Carolina Power & Light Company
PO Box 10429
Southport, NC 28461-0429

SERIAL: BSEP 97-0261

BRUNSWICK STEAM ELECTRIC PLANT, UNIT NOS. 1 AND 2
DOCKET NOS. 50-325 AND 50-324/LICENSE NOS. DPR-71 AND DPR-62
RESPONSE TO REQUEST FOR ADDITIONAL INFORMATION
SEISMIC QUALIFICATION OF MECHANICAL AND ELECTRICAL EQUIPMENT
(NRC TAC NOS. M69433 AND M69434)

Response Spectra - 5% damping

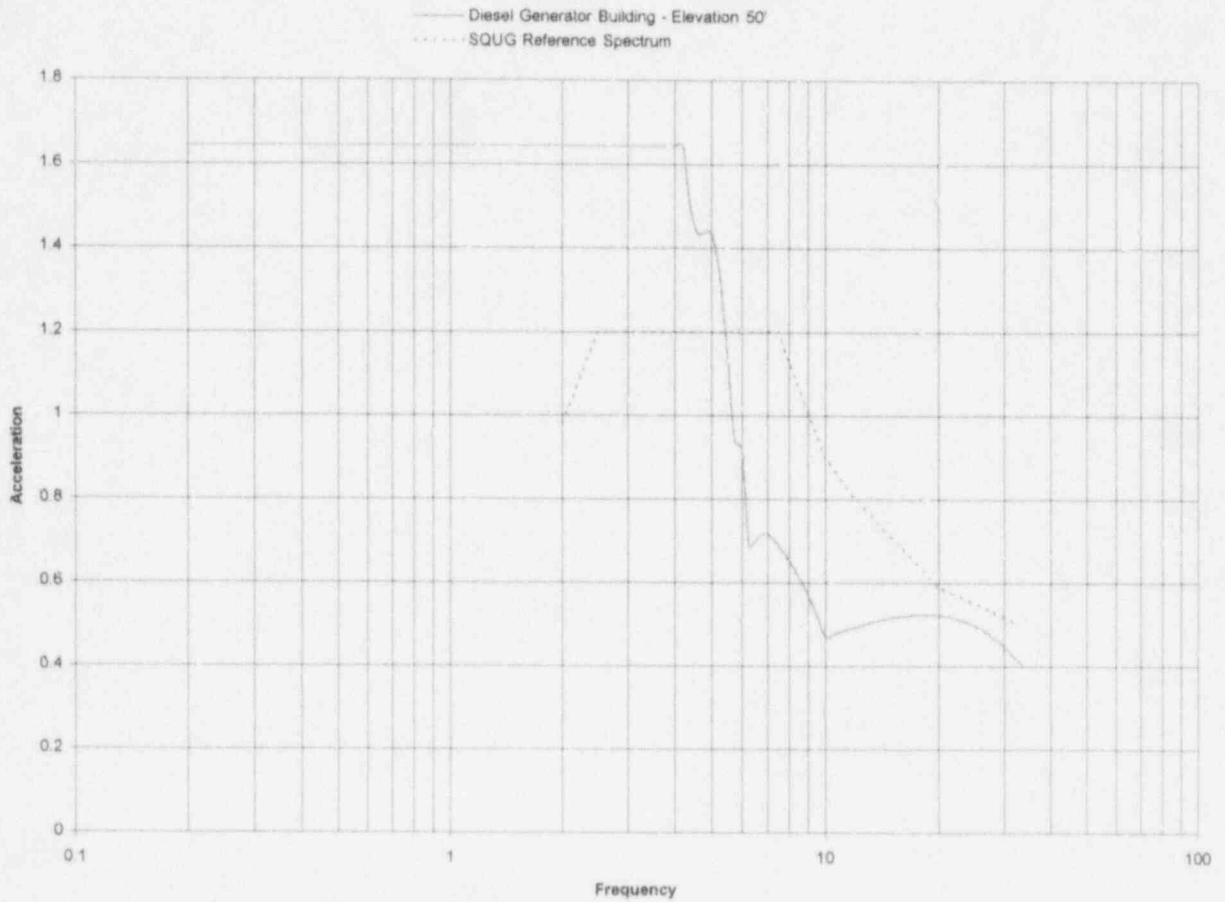
NRC QUESTION #7:

Referring to the in-structure response spectra provided in your 120-day response to the NRC's request in Supplement No. 1 to Generic Letter (GL) 87-02, dated May 22, 1992, the following information is requested:

- a. Identify structure(s) that have in-structure response spectra (5% critical damping) for elevations within 40-feet above the effective grade that are higher in amplitude than 1.5 times the SQUG Bounding Spectrum.

- b. With respect to the comparison of equipment seismic capacity and seismic demand, indicate which method in Table 4-1 of GIP-2 was used to evaluate the seismic adequacy for equipment installed on the corresponding floors in the structure(s) identified in Item (a) above. If you have elected to use method A in Table 4-1 of the GIP-2, provide a technical justification for not using the in-structure response spectra provide in your 120-day response. It appears that some licensees are making an incorrect comparison between their plant's safe shutdown earthquake (SSE) ground motion response spectrum and the SQUG Bounding Spectrum. The SSE ground motion response spectrum for most nuclear power plants is defined at the plant foundation level. The SQUG Bounding Spectrum is defined at the free field ground surface. For plants founded on deep soil or rock, there may not be a significant difference between the ground motion amplitudes at the foundation level and those at the ground surface. However, for sites where a structure is founded on shallow soil, the amplification of the ground motion from the foundation level to the ground surface may be significant.

- c. For the structure(s) identified in Item (a) above, provide the in-structure response spectra designated according to the height above the effective grade. If the in-structure response spectra identified in the 120-day response to Supplement No. 1 to GL 87-02 were not used, provide the response spectra that were actually used to verify the seismic adequacy of equipment within the structures identified in Item (a) above. Also, provide a comparison of these spectra to 1.5 times the Bounding Spectrum.

Original design information for Brunswick did not include 5% damped response spectra. In-structure spectra used for A-46 walkdown inspections and evaluations was generated for the Diesel Generator Building and the Control Building with a conservative damping conversion routine. This conservatism caused some in-structure spectra to exceed the Reference Spectrum as indicated in Table 5-1 of the Seismic Evaluation Report (Enclosure 1 to Reference 1). However, the Diesel Generator Building Elevation 23', the Diesel Generator Pedestal Elevation 23 foot and Elevation 50 foot are the only locations less than 40 feet above effective grade. By converting the damping using the method included in the GIP-2 Part 2 Section 4.4.3, only the in-structure response spectra for elevation 50 foot of the Diesel Generator Building is less than 40 feet above grade and exceeds the Reference Spectrum (plot included below). The shape of the Diesel Generator Building response spectra indicates that the cut-off frequency is more appropriately represented by 33 hertz than 20 hertz as implied in the GIP-2. Therefore, 33 hertz was used instead of 20 hertz in the GIP-2 damping conversion. The frequency range in which the Reference Spectrum is exceeded is less than 8 hertz. Since application of GIP-2 Method A.1 requires the equipment to have natural frequencies of at least 8 hertz, Method B.1 is also applicable using the same restriction. Therefore, all equipment in the Diesel Generator Building at elevation 50' is evaluated to methods other than the GIP-2 Method A.1. The frequency determinations made during the screening walkdowns or those being performed as part of outlier resolutions justify use of Method B.1.
